Final Plat - Comment Response Letter

Citizen on Constitution  
El Paso County, Colorado

Prepared: October 26th, 2022

PCD File Number: SF-226

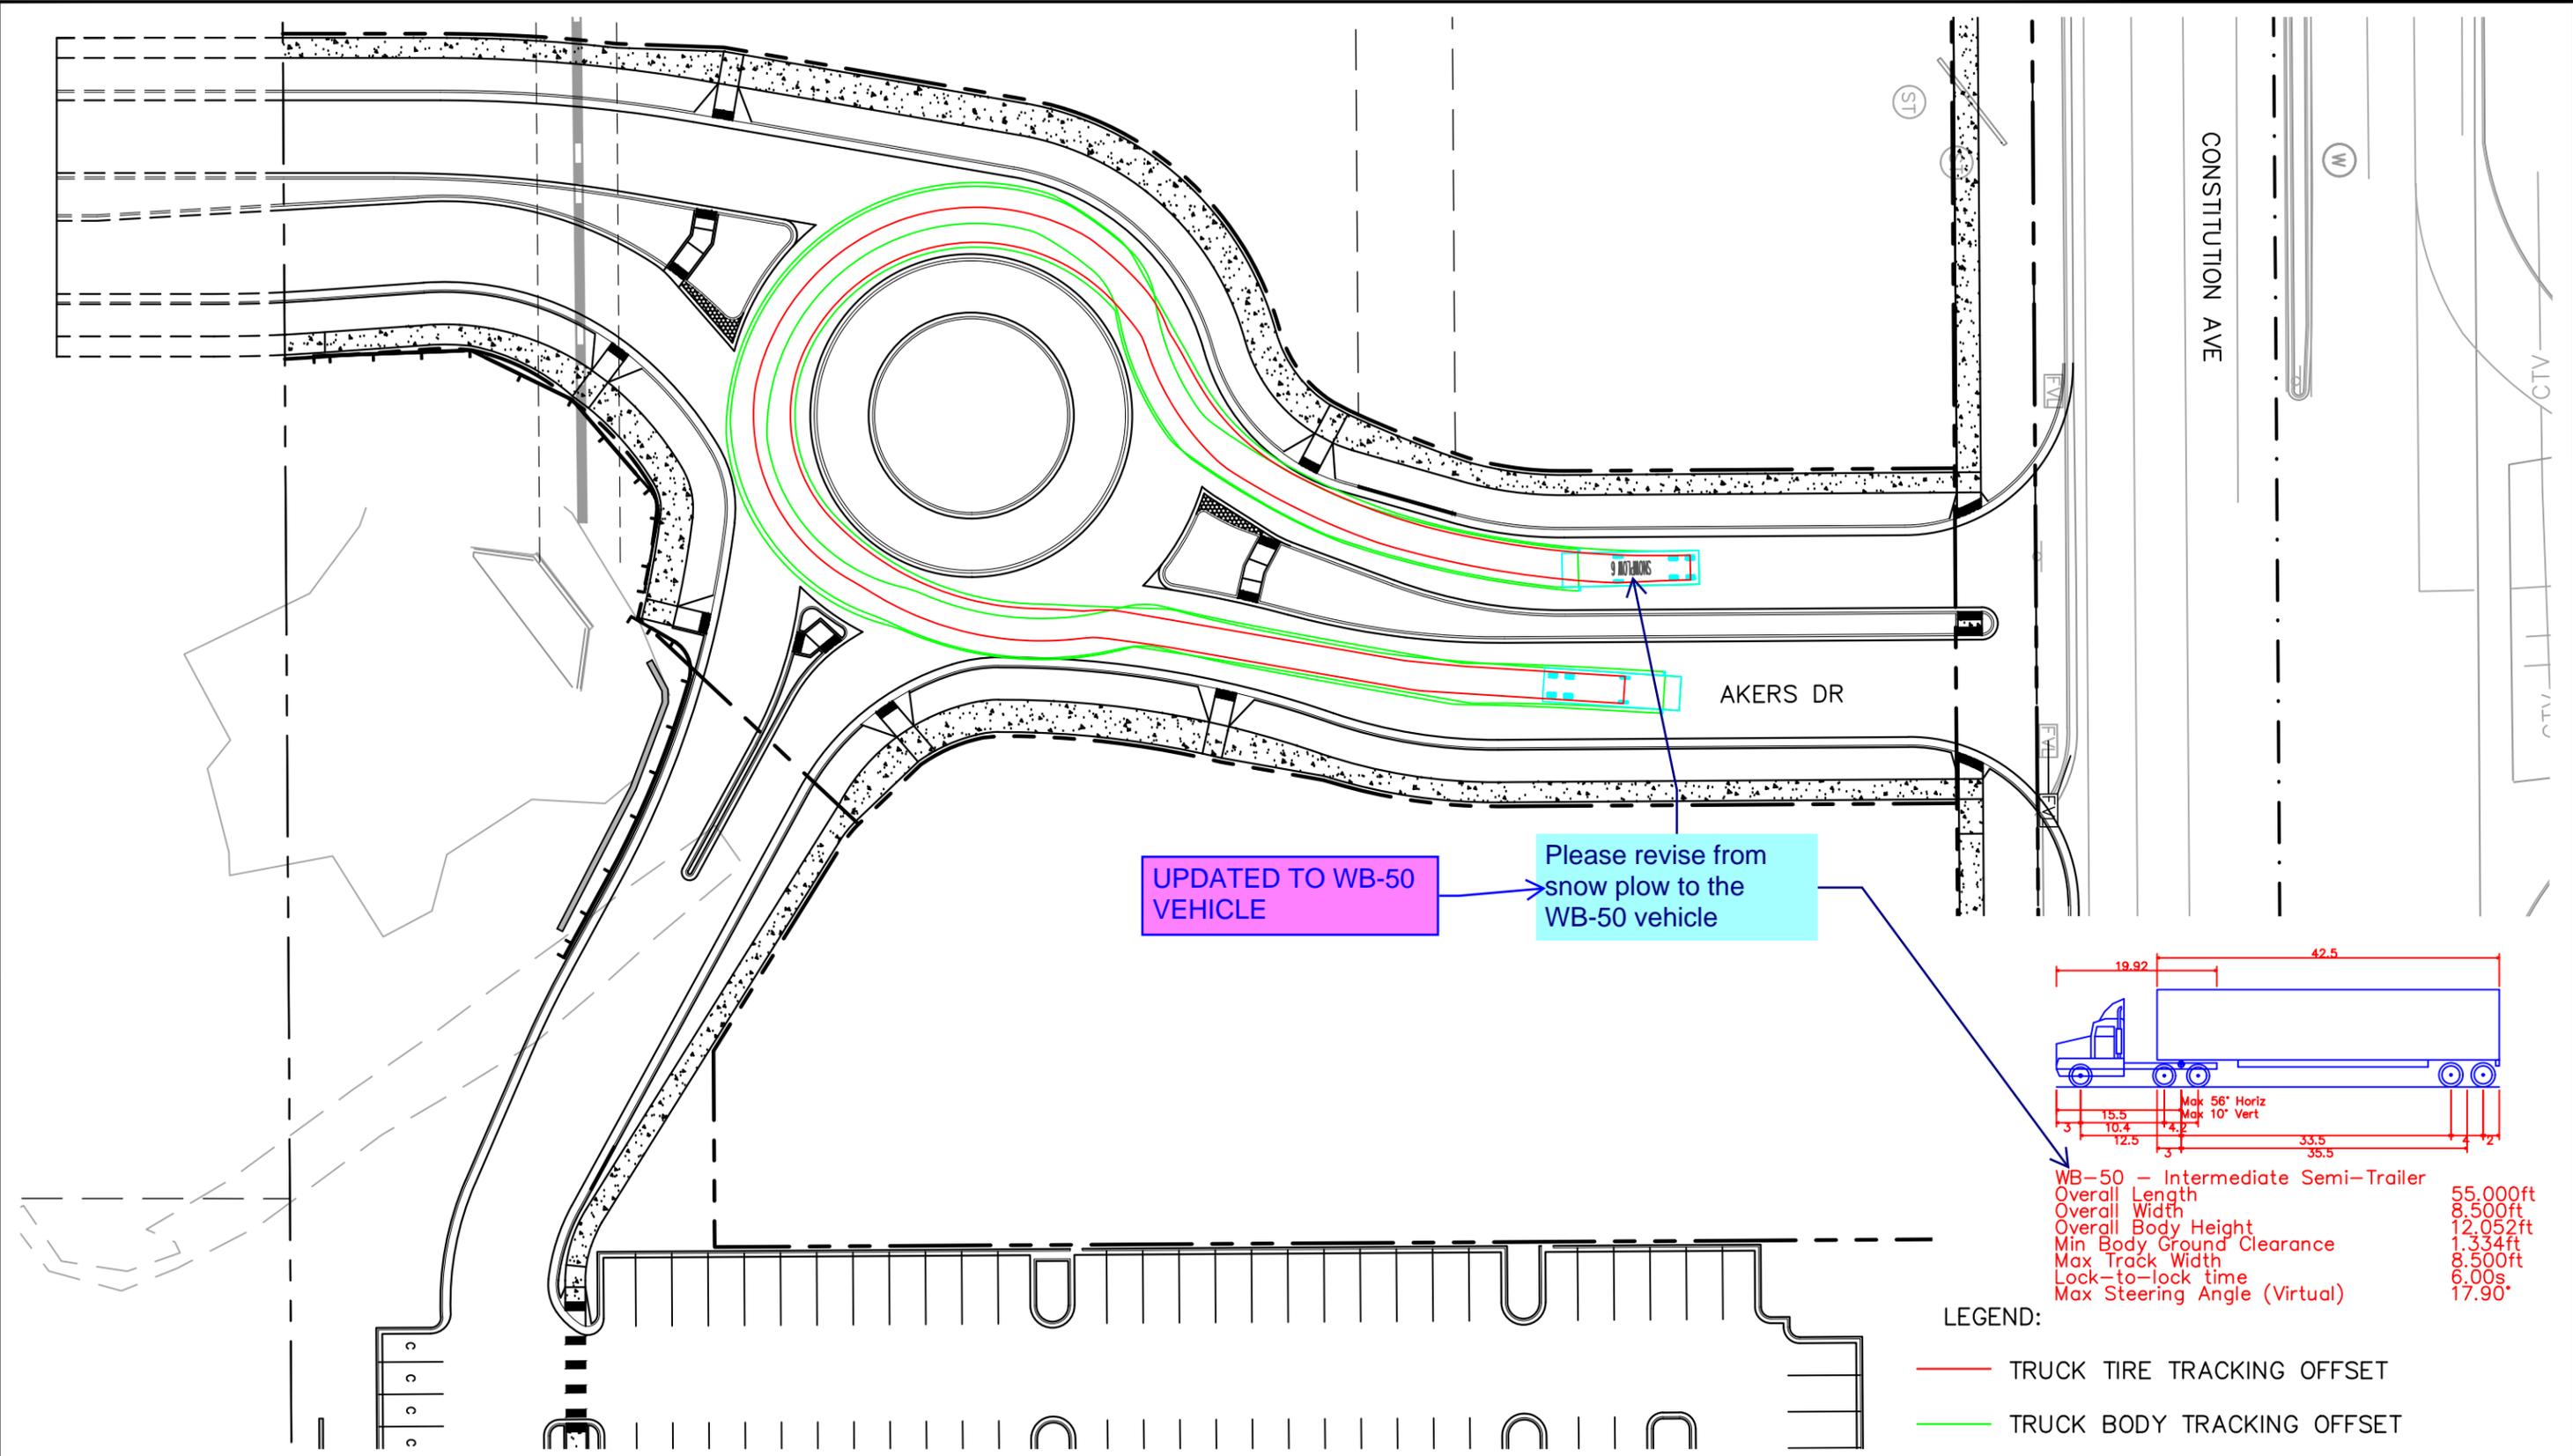
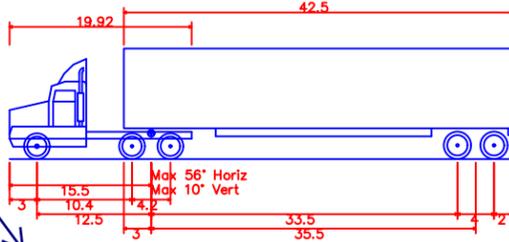
Please revise from snow plow to the WB-50 vehicle

UPDATED TO WB-50 VEHICLE

STORM SEWER LINE A - PROFILE VIEW

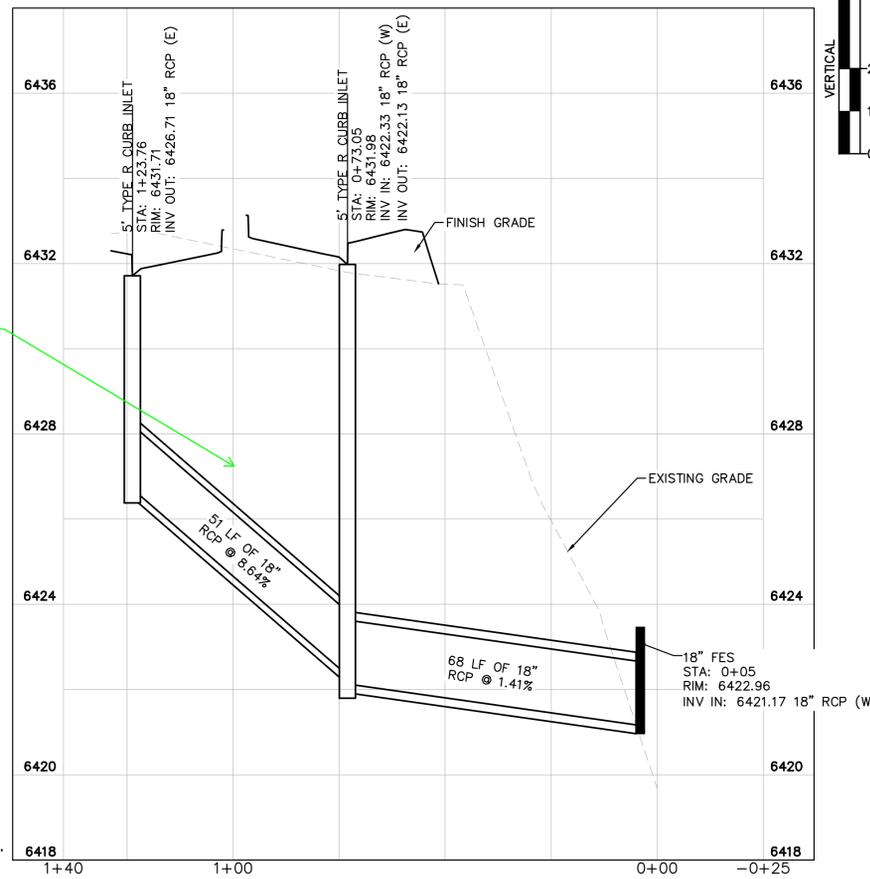
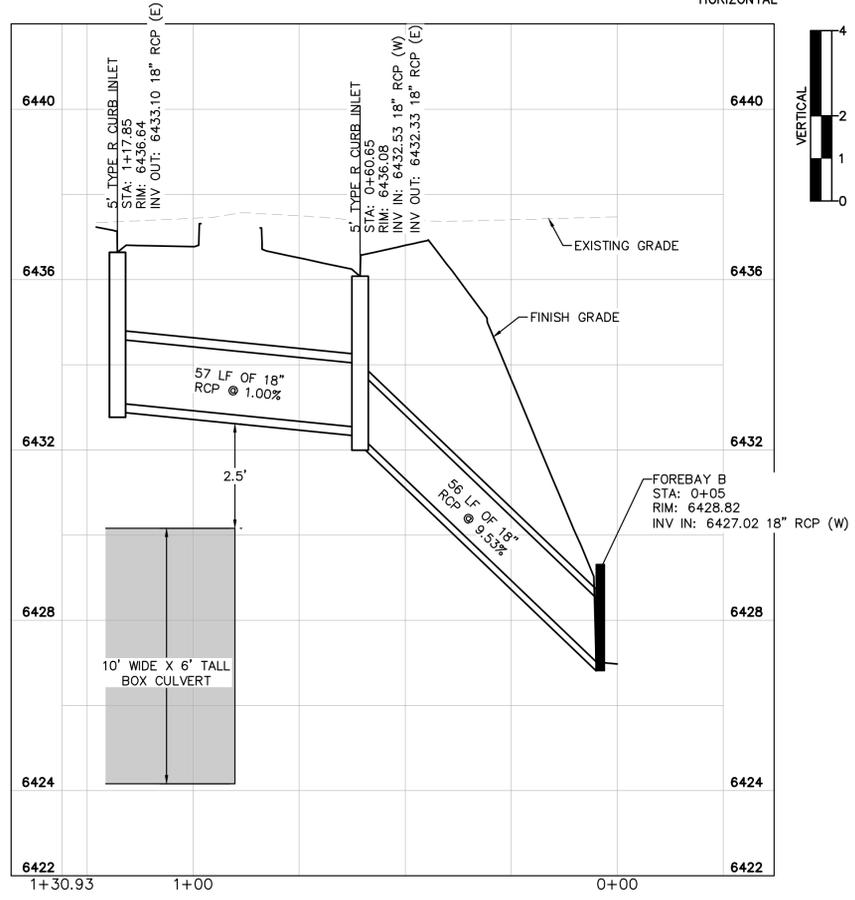
- review 1 comment: show 100 year HGL on all storm profiles.
  - review 2: unresolved
  - Review 3: storm profiles not provided.
  - review 4: Please provide the 100 yr HGL on all storm profiles as indicated in the review 1 comment.
- KH Response: 100-yr HGL's have been added to each profile.

THE CITIZEN ON CONSTITUTION  
EL PASO COUNTY, COLORADO  
UTILITY AND WATER SERVICE PLANS  
**STORM PLAN AND PROFILE LINE I & J**

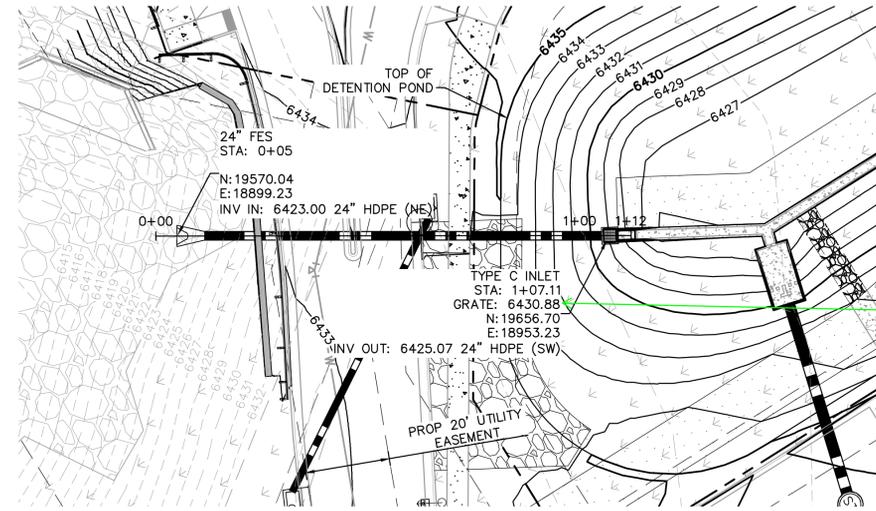
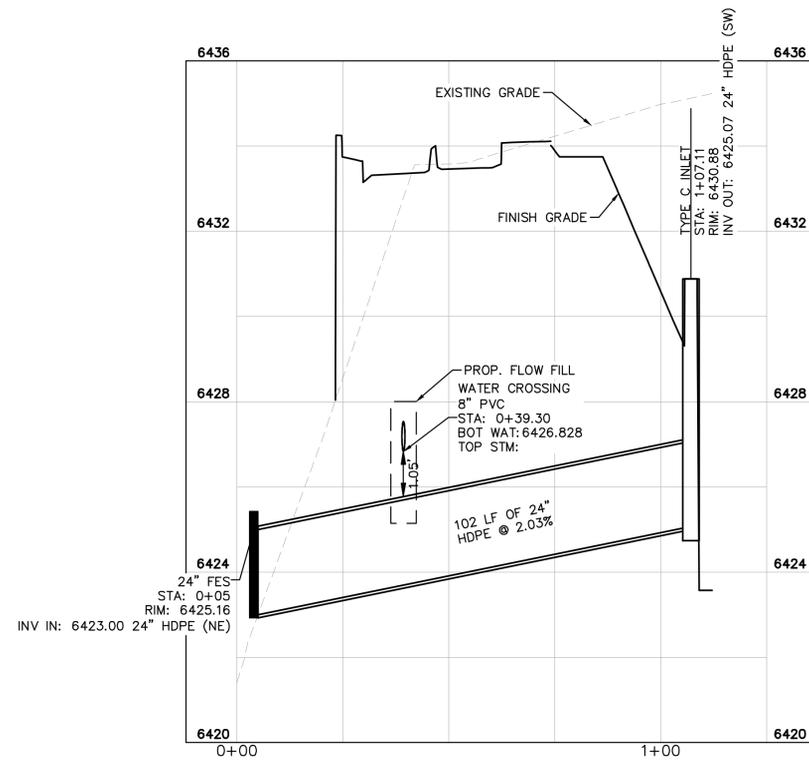
Revise as needed per comment on next sheet.

KH Response: Grate elevation has been revised to 6431.10 to match UD Detention and the details that follow.

AS RE-PLATTED

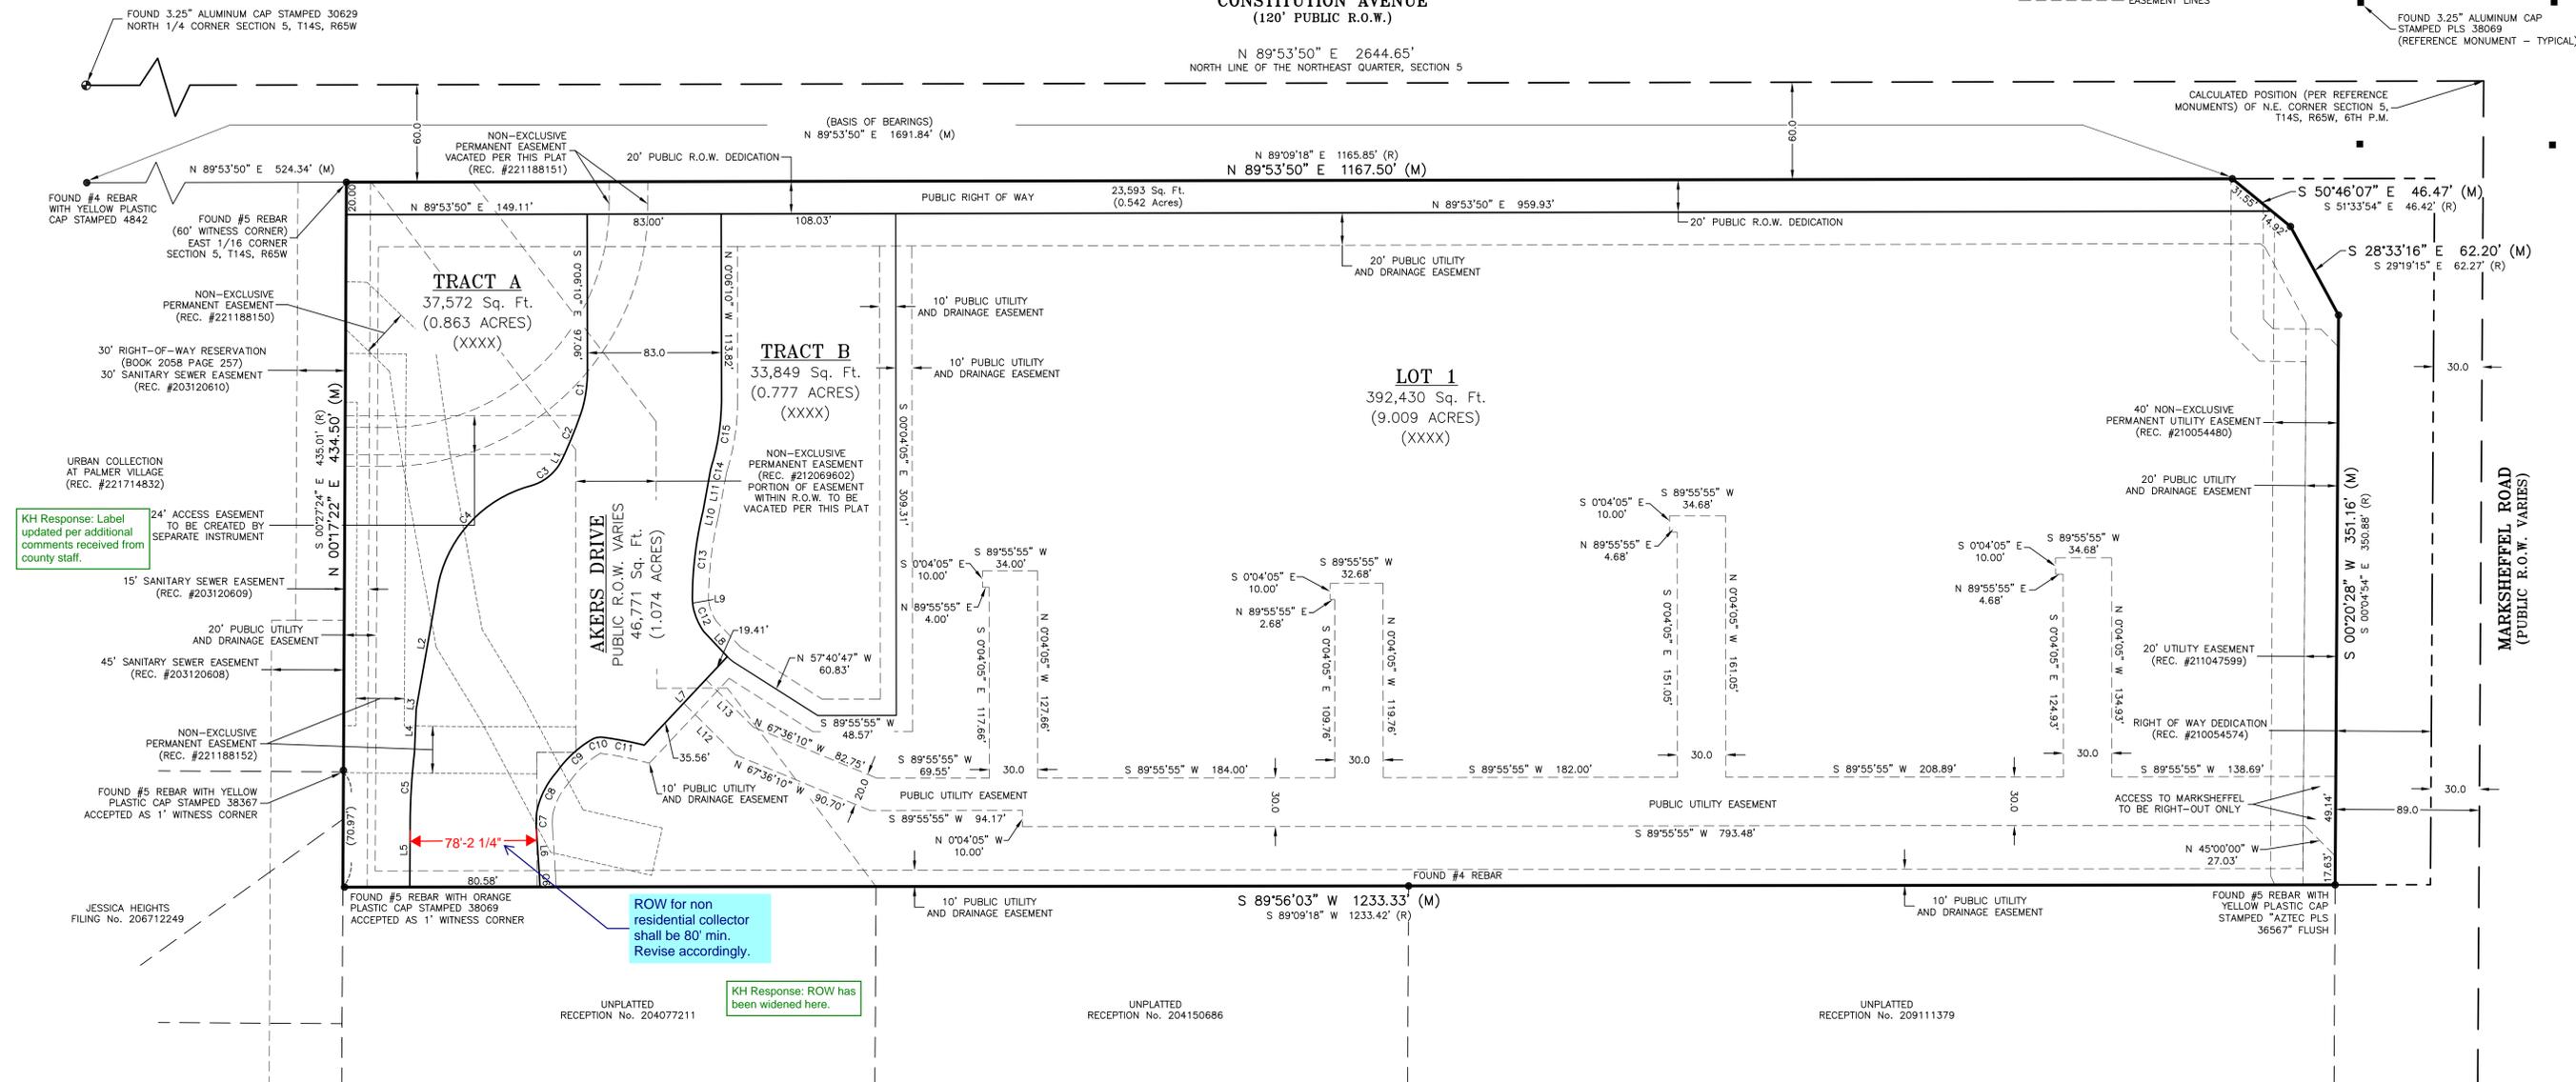
ROW for non residential collector shall be 80' min. Revise accordingly.

KH Response: ROW has been widened here.
